ZONING

REQUEST: Approval of a change in zoning to single family residential to allow for development of a residential subdivision

A request to create a new Planned Development to allow for the development of a single-family residential subdivision.

11-15Z2 Singer Ranch (zoning)

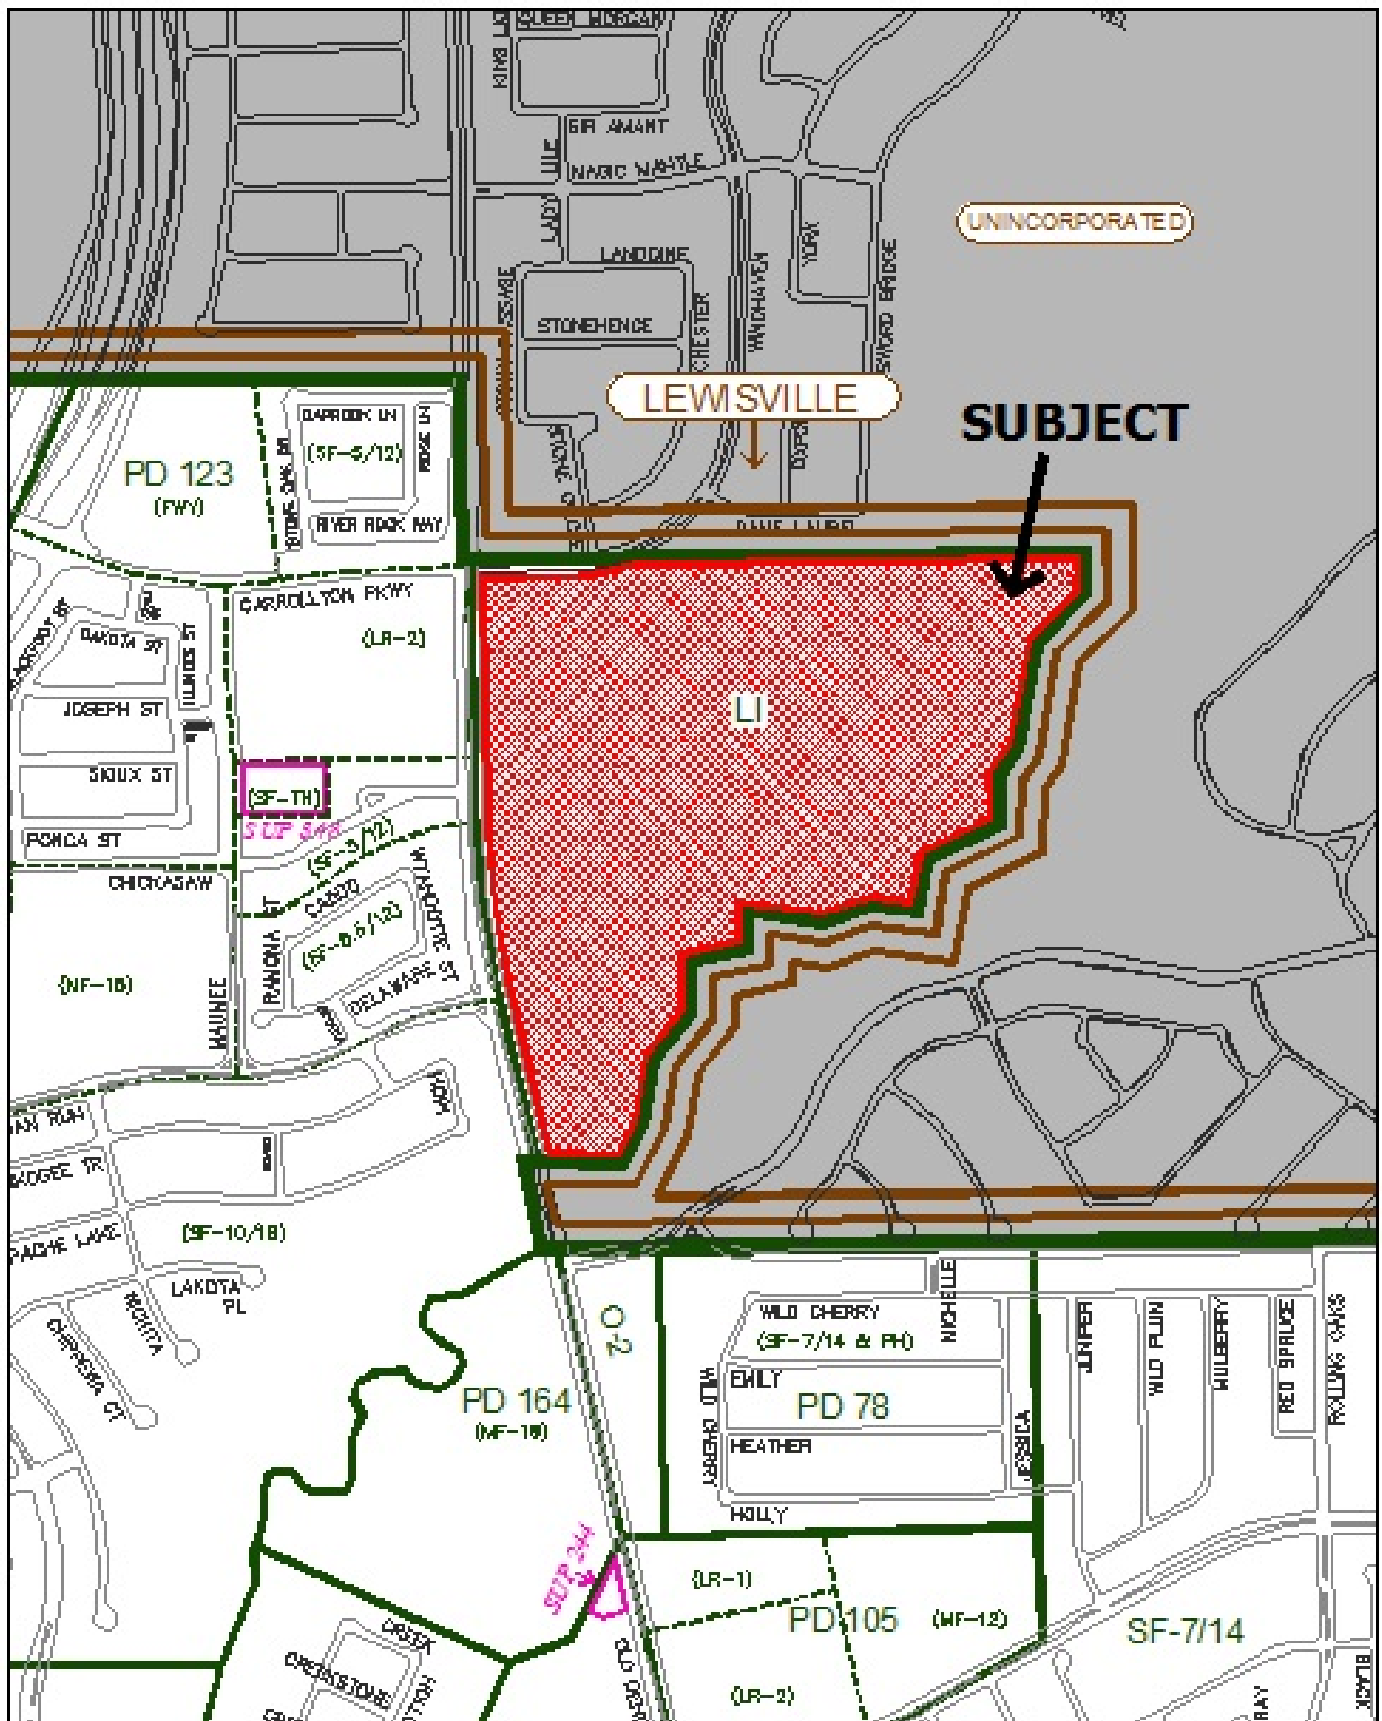
- B. During the design of the preliminary plat, the applicant determined that several lots appeared too small to for the houses they were planning. After further investigation and discussion with staff, the number so affected were determined to be two: Lot 33, Block A (backing up to Old Denton Road near the northwest corner of the subdivision) and Lot 8, Block E, (on a street “elbow” about a block away from the first lot, more internal to the subdivision. See the image below showing the general location of these lots.

The applicant is requesting a further reduction in front yard setbacks (beyond what they are requesting for the subdivision as a whole) as follows:

Lot 33, Block A: additional two-foot reduction, such that the house will be 9 feet, and the garage door will be 18 feet from the front property line

Lot 8, Block E: an additional four-foot reduction in the front yard setback for the garage only, such that the house will remain at 11 feet from the property line, and the garage will be 16 feet from the property line.
